# SERVICE BULLETIN

SERVICE BULLETIN NO: 53-008

## FUSELAGE ENGINE MOUNTING-FRAME ATTACHMENT-FITTINGS - INSPECTION

Engine Mount Attachment Fittings - Inspection/Repair  
Figure 1

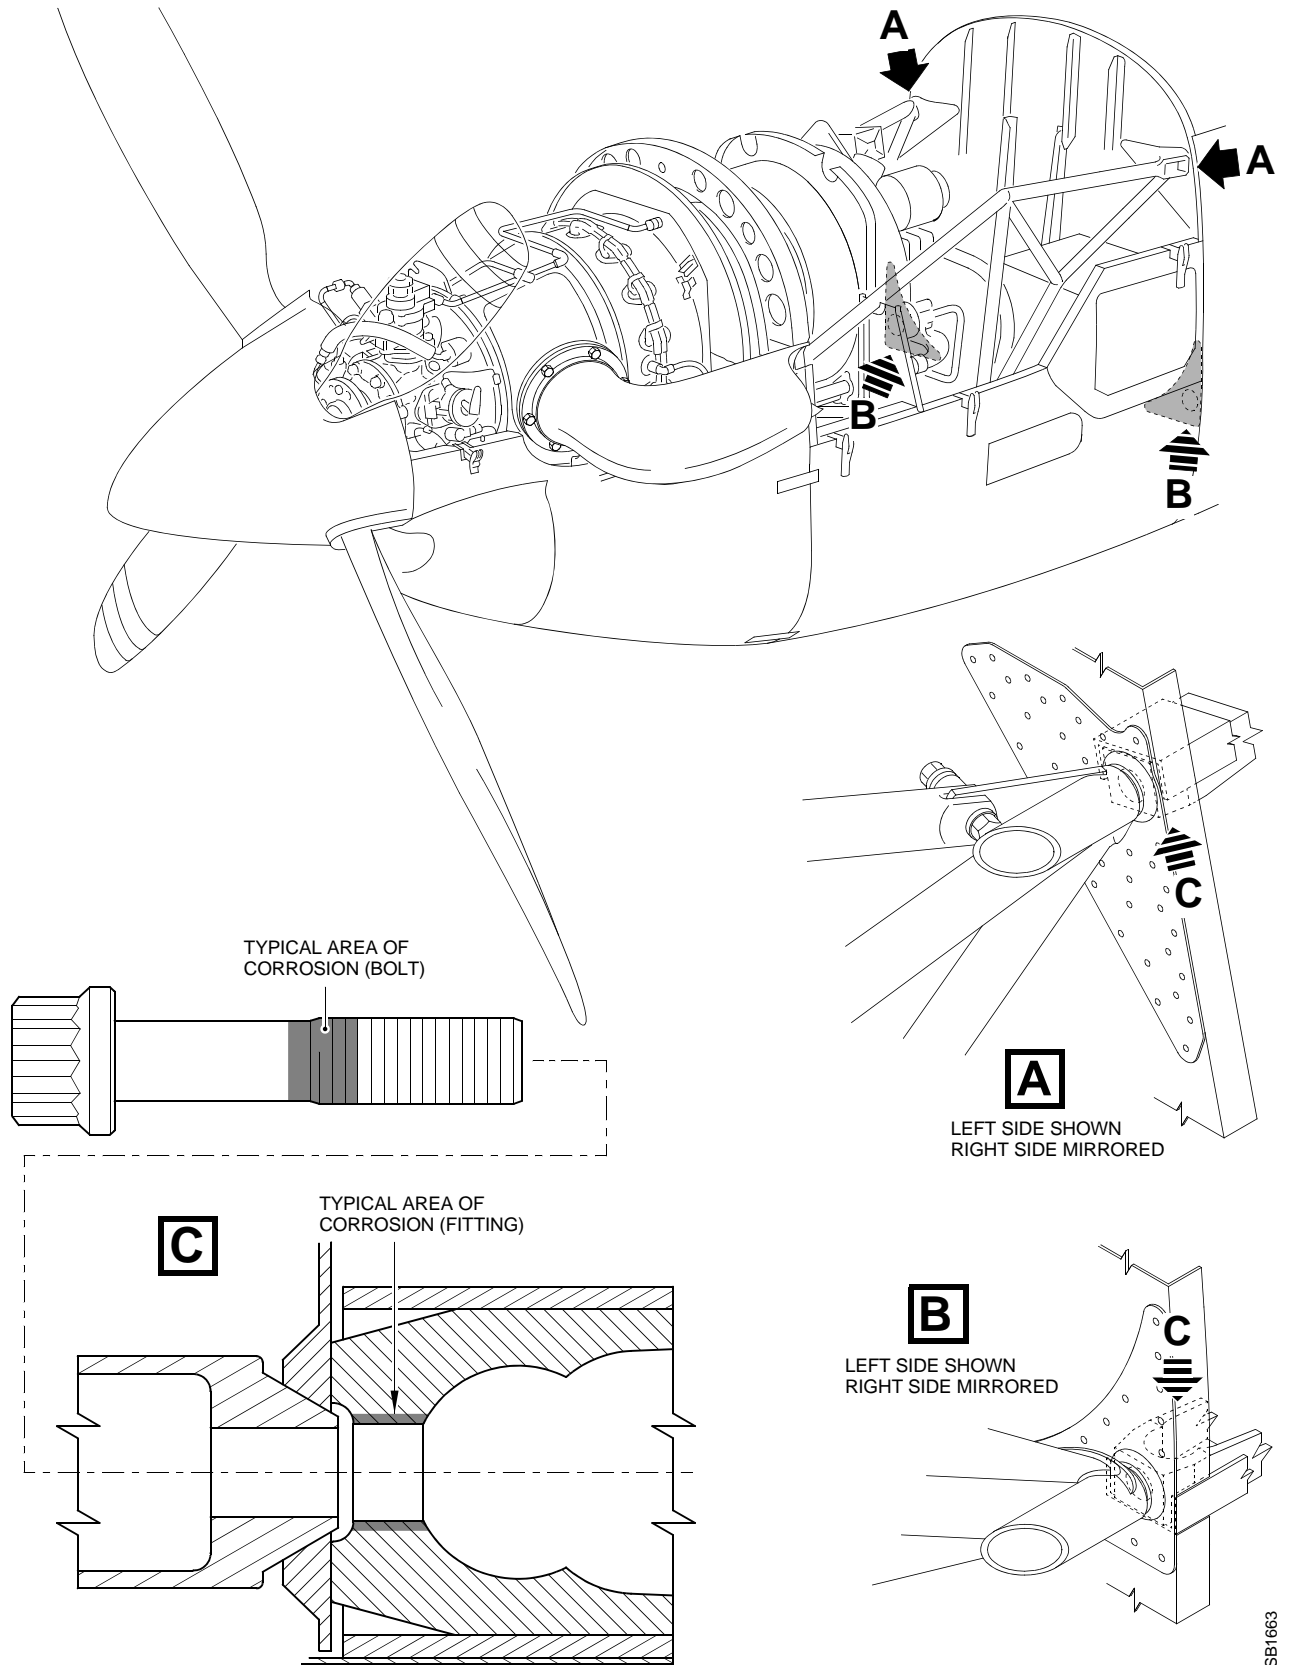
**A. Inspection/Repair (Ref. Fig 1)**

- (1) Remove the bolt and washer from one of the four engine mounting-frame attachment points (Ref. AMM 71-20-01, Page Block 401).
- (2) Do a visual inspection for corrosion on the removed bolt.
- (3) Do a visual inspection for corrosion in the bore of the attachment fitting. Do this with a boroscope. If you find corrosion, do the subsequent steps:

- (a) Use aluminum wool (Material No. P02-002) to remove surface corrosion.
- (b) If you cannot remove all of the corrosion contact Pilatus for repair information.

- (c) Clean the bore and the threads of the barrel nut with solvent (Material No. P01-008) and absorbent paper (Material No. P02-031).
- (d) Remove all swarf and debris from the attachment fitting. If necessary, you must remove the barrel nut and/or the engine mounting frame to do this. Make sure there is no swarf and debris in the joints between:

- The attachment fitting and the barrel nut
  - The attachment fitting and the engine mounting frame.
- (e) Apply a layer of CCC solution (Material No. P07-001) to the bore.

- (f) If necessary, install the barrel nut and/or the engine mounting frame.
- (4) Install the new bolt (P/N 571.20.09.031) and the washer (P/N 938.75.11.105) (Ref. AMM 71-20-01, Page Block 401).
